SOLICITATION AMENDMENT MODIFICATION DE L'INVITATION

Title - Sujet CCGS Samuel Risley refit 2014	
Solicitation No. - N° de l'invitation F2599-145028/A	Amendment No. - N° modif. 010
Client Reference No. - N° de référence du client F2599-145028	Date 2014-06-17
GETS Reference No. - N° de référence de SEAG PW-\$\$MD-018-24496	
File No. - N° de dossier 018md.F2599-145028	CCC No./N° CCC - FMS No./N° VME
Solicitation Closes - L'invitation prend fin at - à 02:00 PM on - le 2014-07-03	Time Zone Fuseau horaire Eastern Daylight Saving Time EDT
F.O.B. - F.A.B. Plant-Usine: <input type="checkbox"/> Destination: <input type="checkbox"/> Other-Autre: <input type="checkbox"/>	
Address Enquiries to: - Adresser toutes questions à: Vandal, Paul	Buyer Id - Id de l'acheteur 018md
Telephone No. - N° de téléphone (819) 956-0645 ()	FAX No. - N° de FAX (819) 956-0897
Destination - of Goods, Services, and Construction: Destination - des biens, services et construction:

Delete Amend. No. 9 in it's entirety and Replace with Amend. No. 10.

QUESTIONS AND ANSWERS

Figure 4

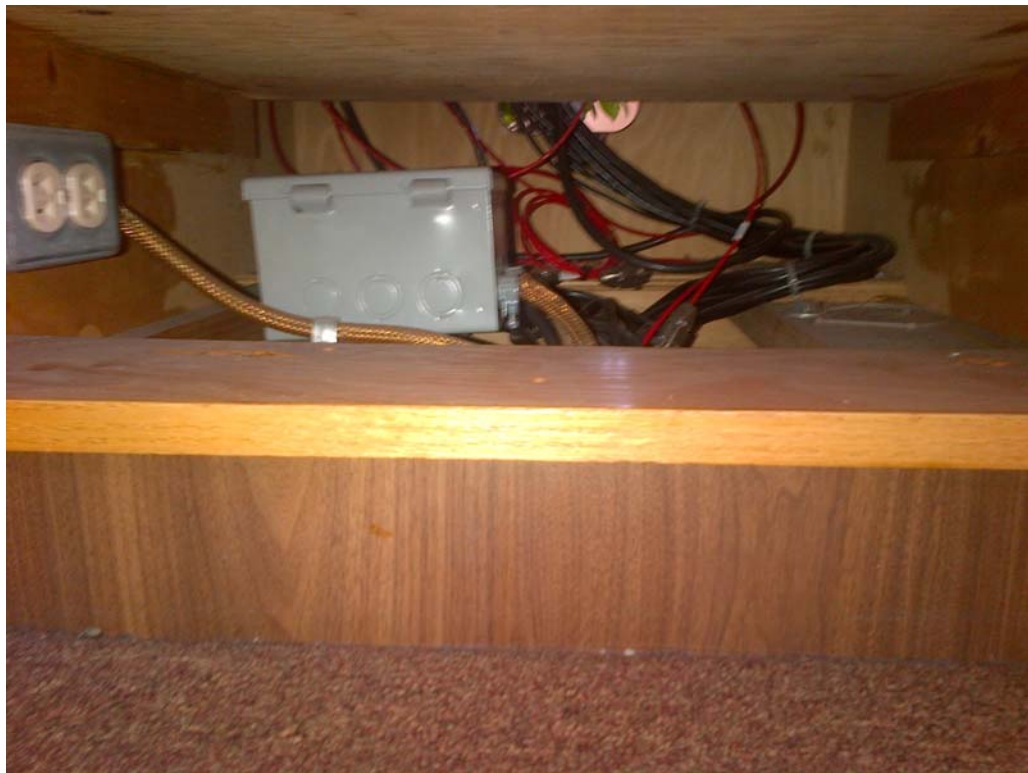
15.5.24.14 Following the removal of the Starboard Radar Display Console in the preceding paragraph, the Contractor shall:

- a) Consult with the CCG E&I Representative to identify existing electrical cables located under the Starboard Radar Display Console. The goal is to identify cables for subsequent re-routing, if necessary (See figure 4, below);
- b) Budget labour in the amount of 20 hours to reroute/move electrical cable, outlets, and junction box located directly beneath the old Starboard Radar Display Console. Wire size to be 14 AWG (2.5mm²) maximum;
- c) Budget materials and labour in the amount of 40 hours to modify, strengthen, treat and prepare the existing deck structure to fit a new Plinth for the Starboard Radar Display Console; and
- d) Install a new GFE supplied Console Plinth/Platform with the goal of providing a solid base for the new Starboard Radar Display Console. The new Console Plinth/Platform shall be aligned fore and aft.
